TSIB 26-08 Rev A		July 28, 2026
TO:	All Xcelsior Operators	
TITLE:	Tandem Air Dryer Banjo Bolts Update	
APPLICABILITY:	All Haldex Tandem Air Dryers equipped Xcelsior buses

This bulletin introduces new improved banjo bolts for Haldex tandem air dryers. The updated banjo bolts feature enhanced corrosion resistance and are designed to replace the current banjo bolts to help minimize corrosion-related issues that may affect air dryer performance and reliability. This bulletin is not a retrofit campaign and replacement is not mandatory. The improved banjo bolts are available for customers who wish to proactively upgrade their existing components. Replacing the current banjo bolts with the improved design can help increase long-term durability, improve system reliability, and reduce the risk of service interruptions caused by corrosion.

Figure 2: M22 Banjo Bolts Location on CONSEP Area.

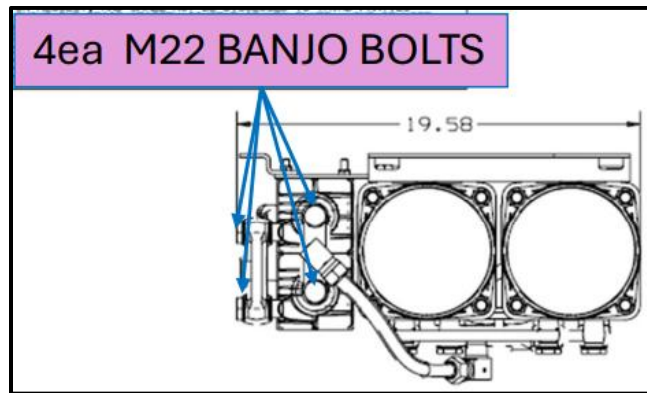
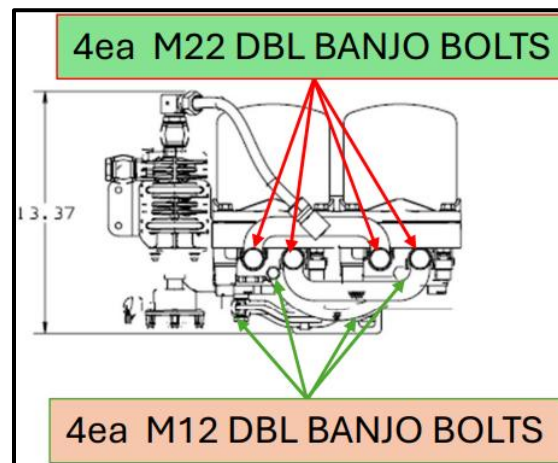
4. Remove M22 Banjo Bolts/washers and replace with the new M22 Banjo Bolts/washers (Zinc Flake Coating) from the banjo bolt kit (NF PN: 6701924). **Torque M22 banjo bolts to 44 to 55 ft-lbs.**
5. Remove M12 Banjo Bolts/washers and replace with the new M12 Banjo Bolts/washers (Zinc Flake Coating) from the banjo bolt kit (NF PN: 6701924). **Torque M12 banjo bolts to 130 to 150 in-lbs.**

Note: Apply a small amount of silicone grease to green part of banjo bolt seals.

Figure 5: M22 and M12 Banjo Bolts Location in Front and Bottom of Assembly

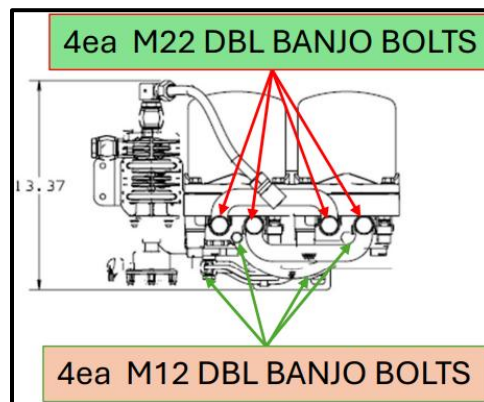
3. Remove M22 Banjo Bolts/washers and replace with the new M22 Banjo Bolts/washers (Zinc Flake Coating) from the banjo bolt kit NF PN: 6480393. **Torque M22 banjo bolts to 44 to 55 ft-lbs.**
4. Remove M12 Banjo Bolts/washers and replace with the new M12 Banjo Bolts/washers (Zinc Flake Coating) from the banjo bolt kit NF PN: 6480393. **Torque M12 banjo bolts to 130 to 150 in-lbs.**

Note: Apply a small amount of silicone grease to green part of banjo bolt seals.
